KANGOO
CLIO II

31 STANDARDISATION OF SUB-FRAMES

This Technical Note deals with the replacement of a KANGOO or CLIO II engine sub-frame with new standardised sub-frames.

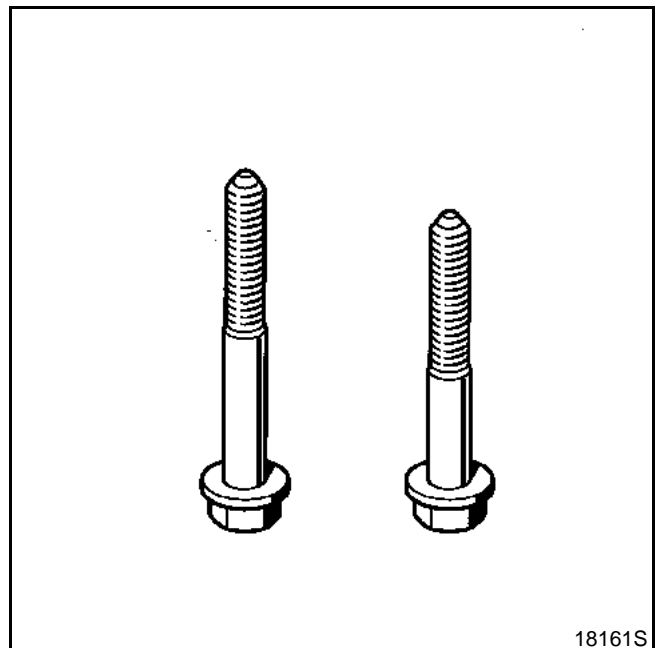
WARNING: some parts **must be replaced or removed** when the sub-frame is replaced with the new sub-frame (**Part no.: 82 00 036 128**).

Mounting bolt (1) on the right-hand rear sub-frame should be replaced by bolt (**Part no.: 77 03 602 078**). The centring bushings (2) **must not be refitted**.

18161S

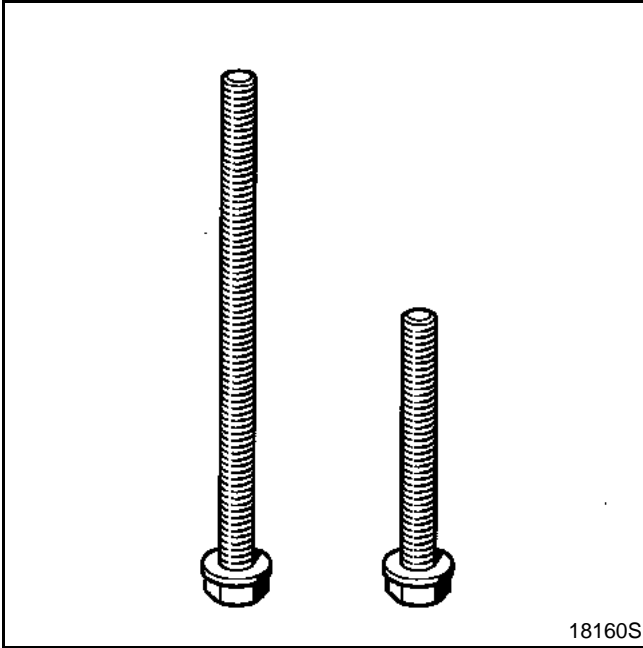
The lower mounting bolts on the steering rack must be replaced by bolts (**Part no.: 77 03 101 410**). These are shorter to accommodate the modification made to the sub-frame. If the vehicle is fitted with acoustic tie rods (3), these **must not be refitted**.
